TOWN OF JACKSON PLANNING & BUILDING DEPARTMENT

Date: December 9, 2022	REQUESTS:
Item #: P22-288	
Planner: Katelyn Page	
Phone: 733-0440 ext. 1302	
Email: kpage@jacksonwy.gov	
Owner Carol & Ramon Tome 3775 Randall Mill Rd.NW Atlanta, GA 30327	
Applicant Cornelius Kinsey – Kinsey, LLC PO Box 12258 Jackson, WY 83002	
Please respond by: December 23, 2022 (with Comments)

The applicant is submitting a request for a Grading Pre-Application Conference for 410 E Gill, legally known LOTS 1,2,3, BLK. 5, L.G. GILL SUBDIVISION PIDN: 22-41-16-27-3-08-002

Name/Description: Tome Single-family residence with ARU

JOB TITLE: TOME RESIDENCE
DRAWING NO: C2.0
JOB NO: 21-525-02

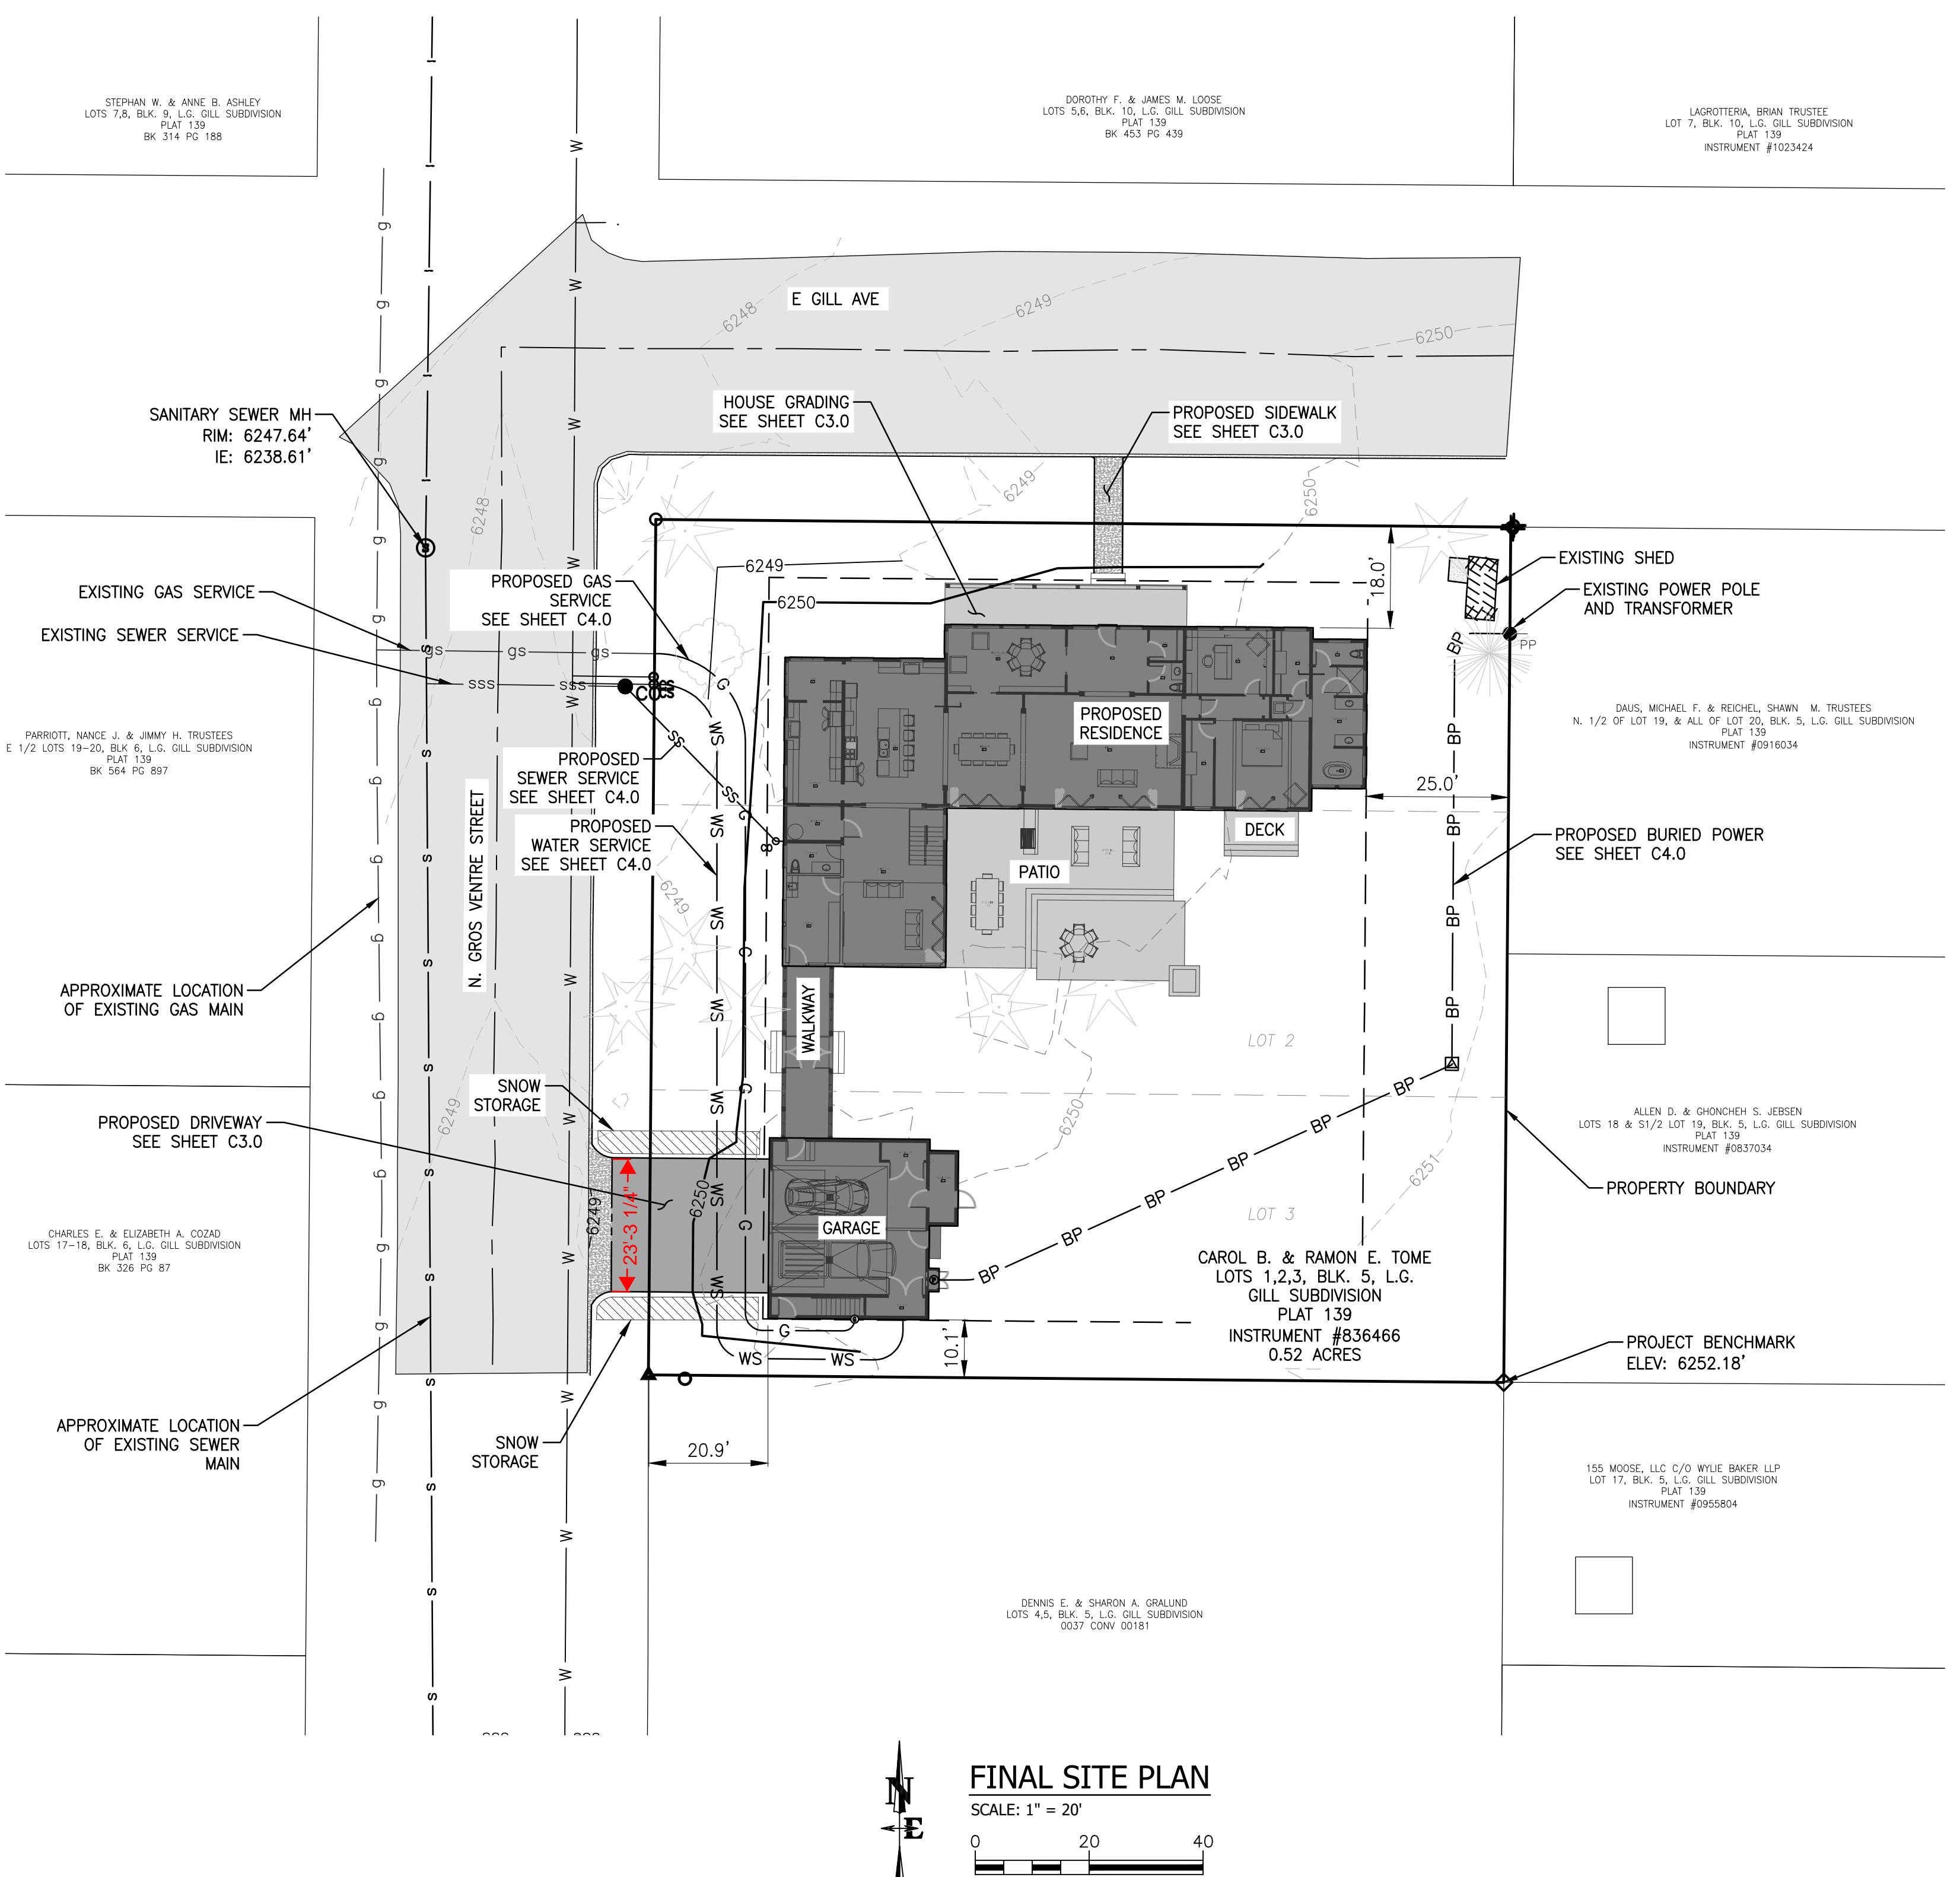
- Parking - Show total parking of 4 spaces (2 for primary dwelling and 2 for ARU (rounded from 1.5). ARU shall be provided past the parking setback of 10' on secondary street and 20' on primary street. Current plans do not successfully accommodate required ARU parking. Revise.

- Curb cut max is 20'. Plans appear to show wider than allowed curb cut.
- List site development sf on plans
- Lumen allowance is 1.5 lumens /sf of site development

A2.2

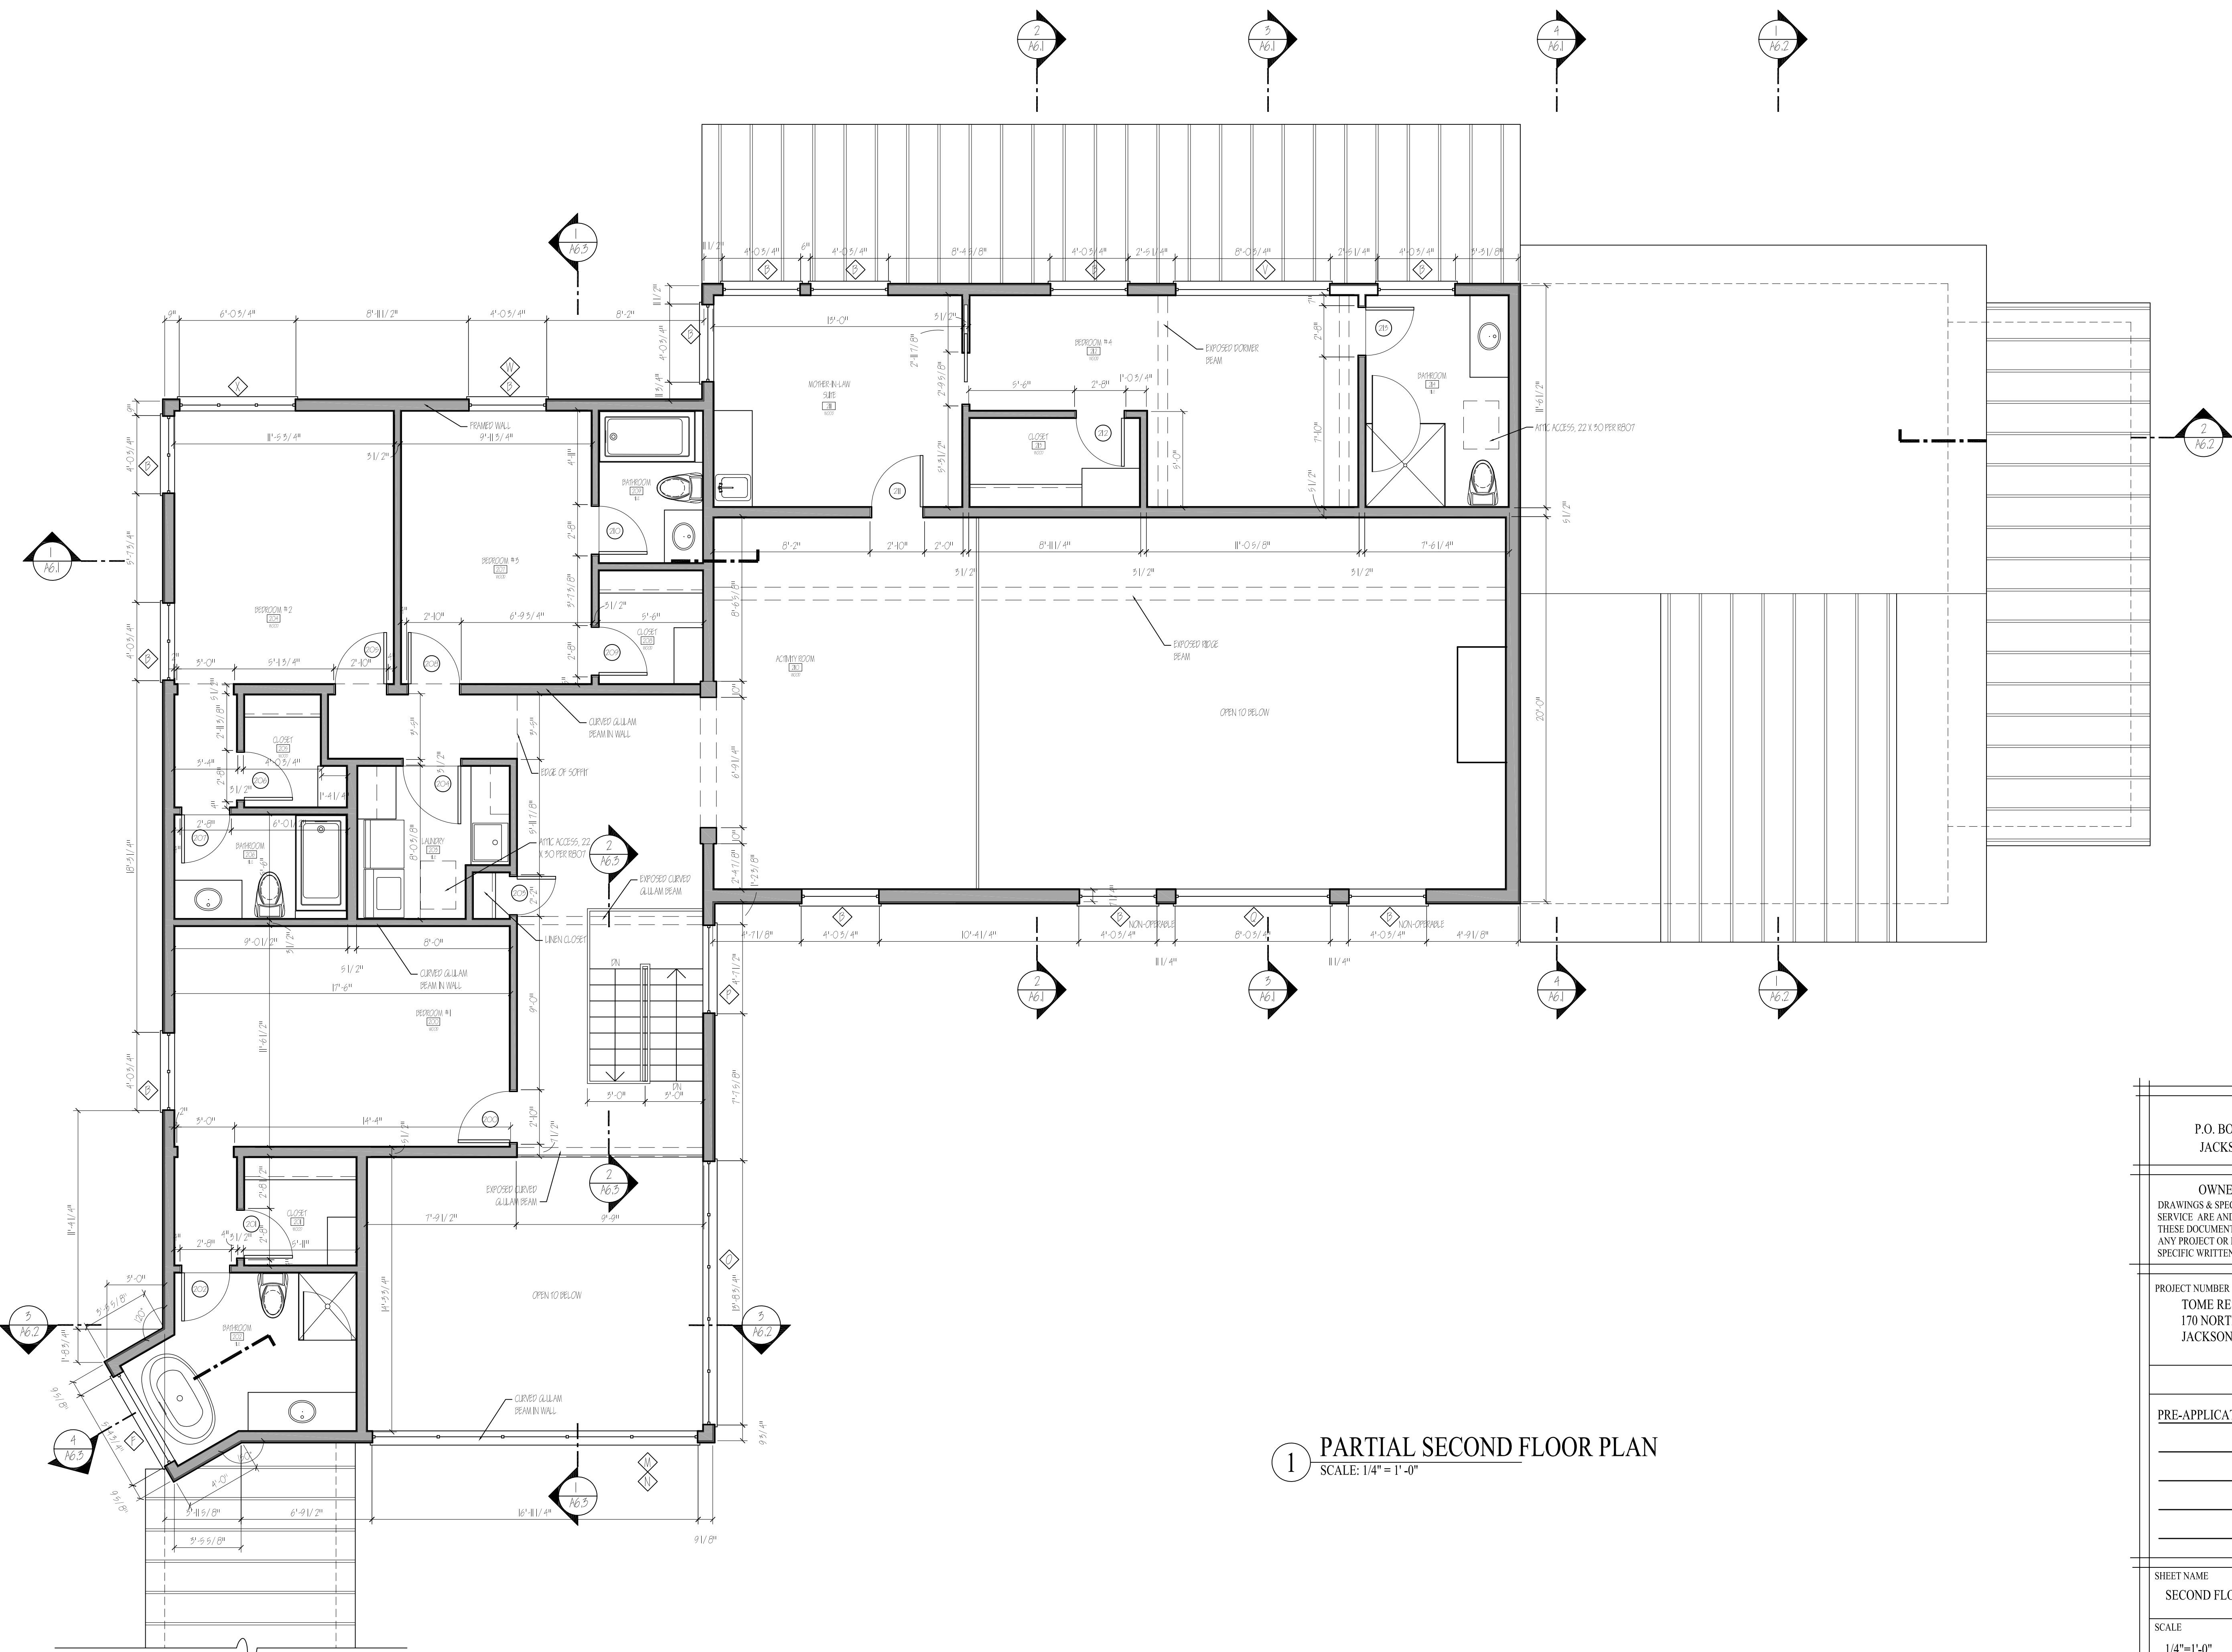
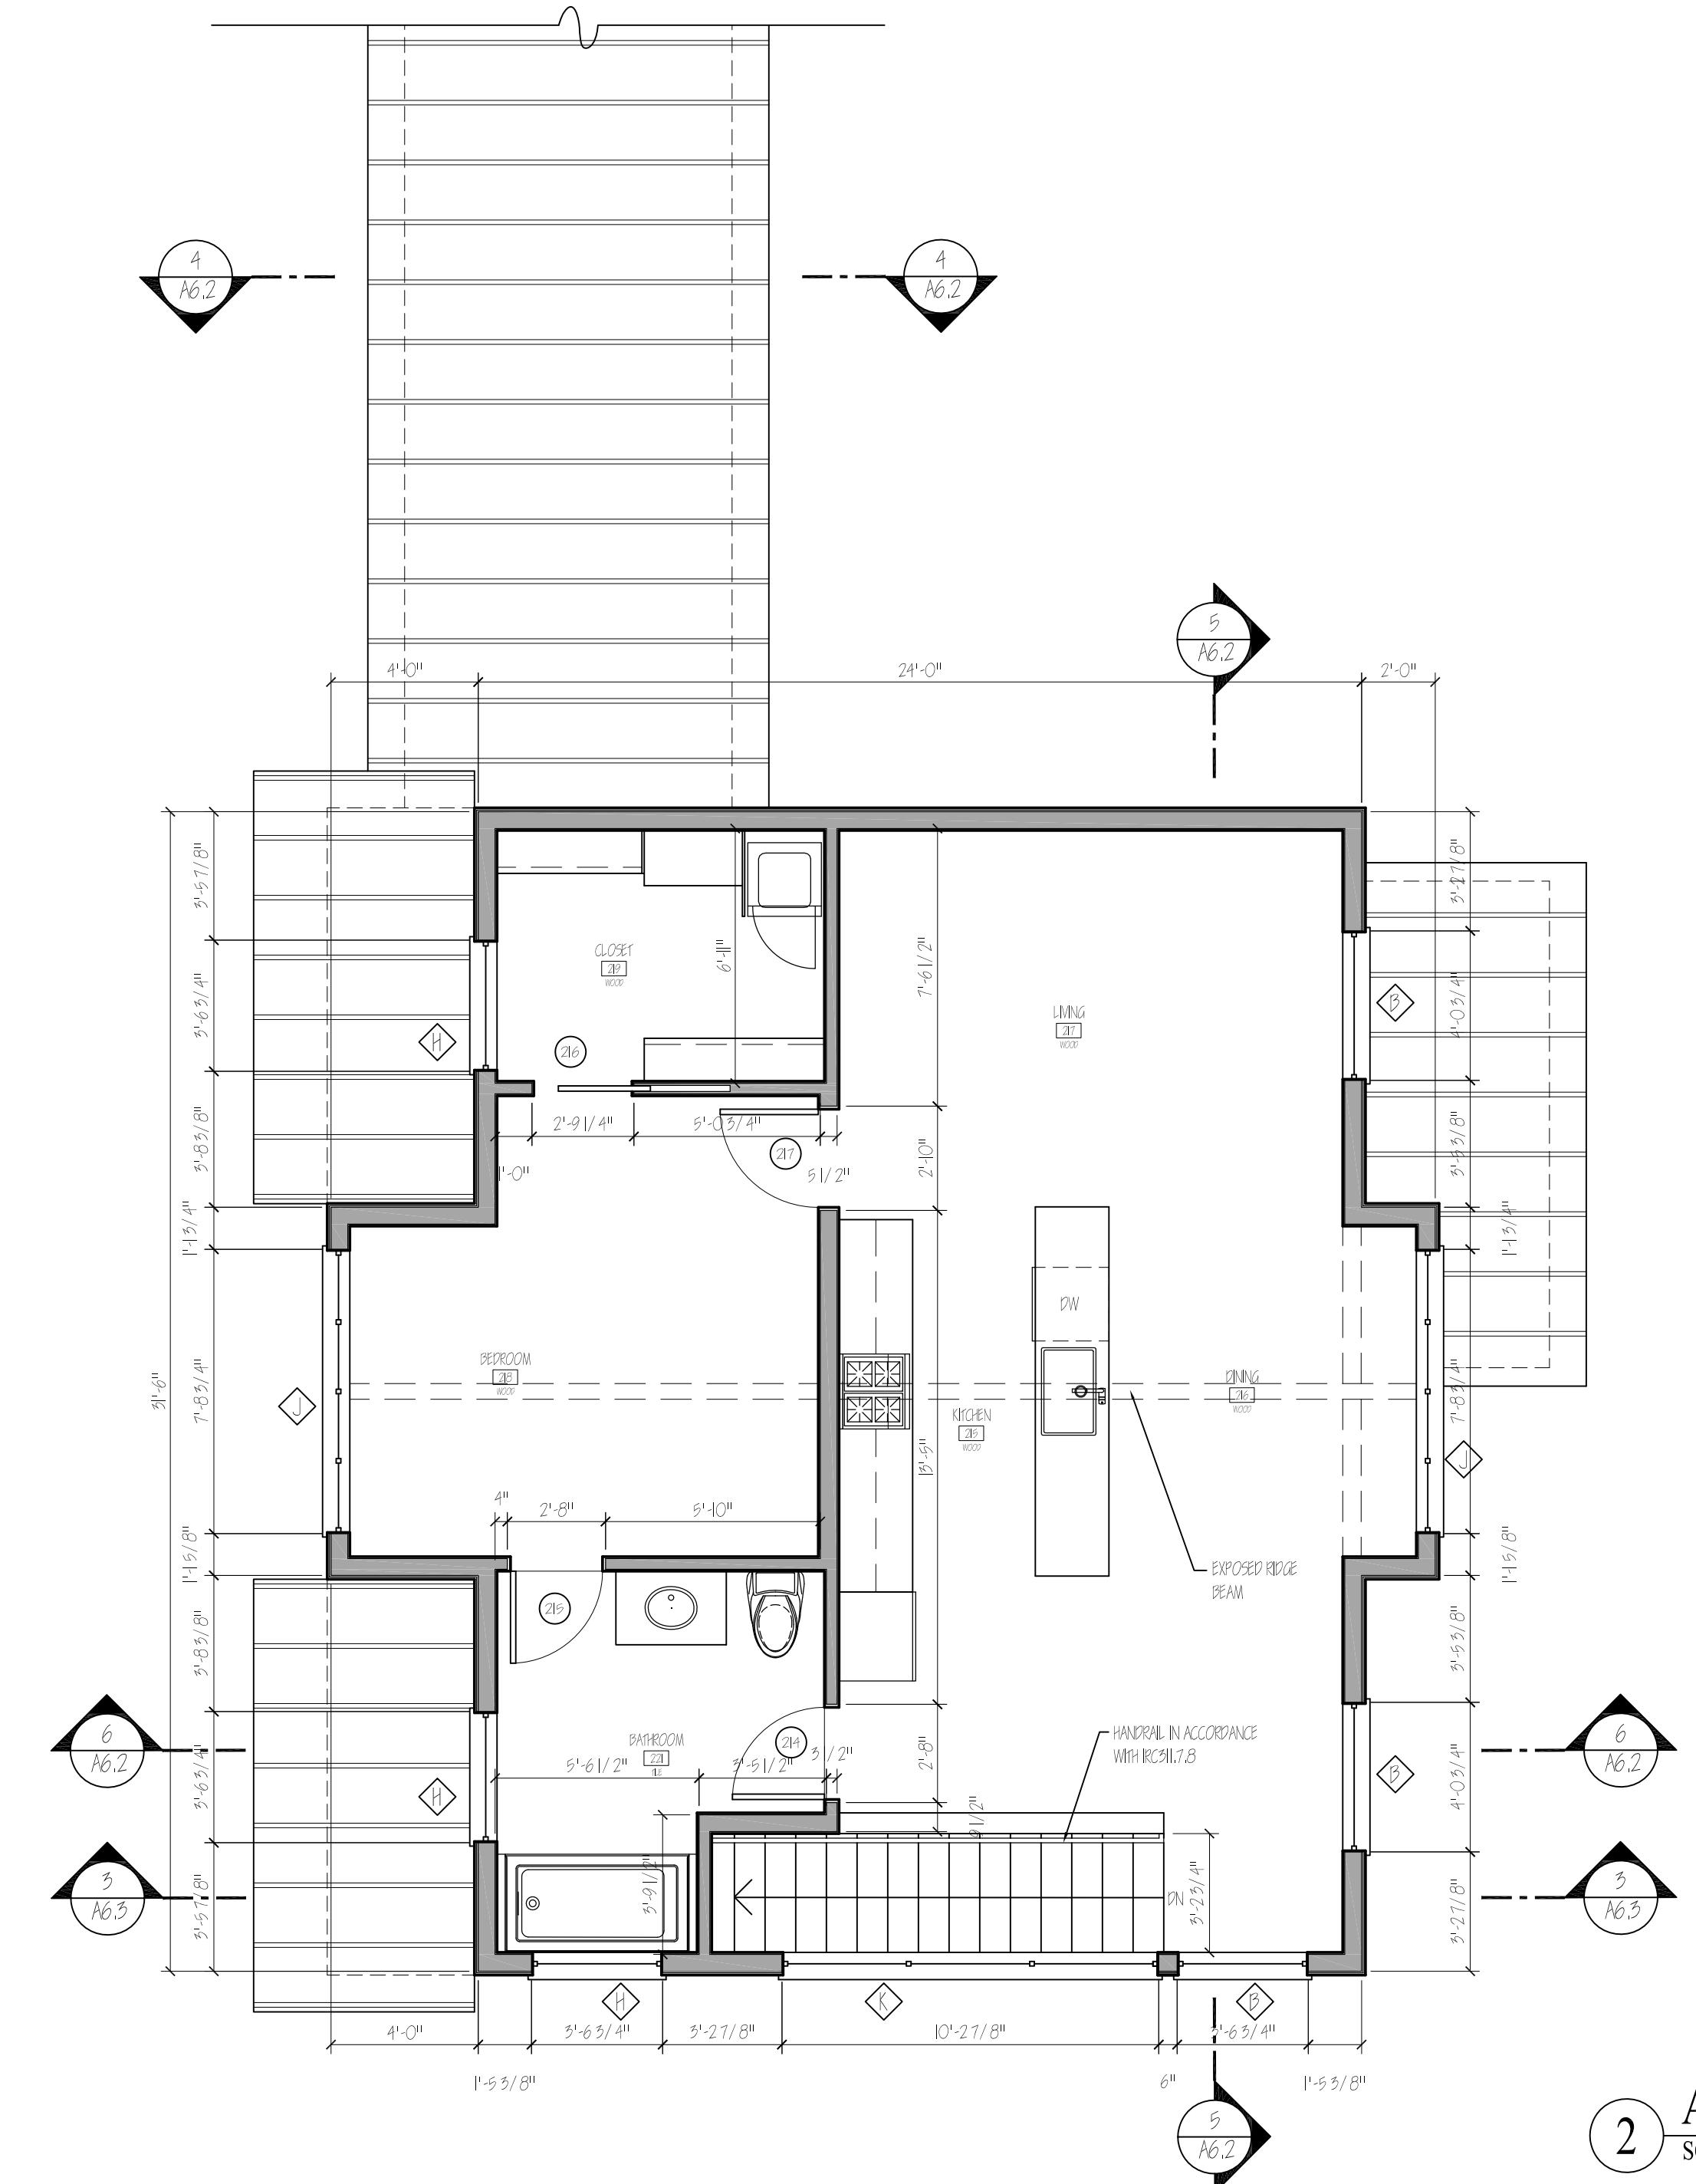
- Structure does not meet primary street setback of 20'
- Revise encroachment - Porch encroachment on E. Gill is must be no greater than 6'. (Sec. 9.4.8.J.a) Cornices, canopies, eaves, decks (covered and uncovered), porches, balconies, bay windows, chimneys and similar architectural features may encroach into a front yard by not more than 6 feet.

- Need ARU parking
- Orientation
- “Detached” non detached with walkway
- Front encroachment is greater than 6' (6'-7") (A2.2)
- Clarify building height
- Verify parking setbacks
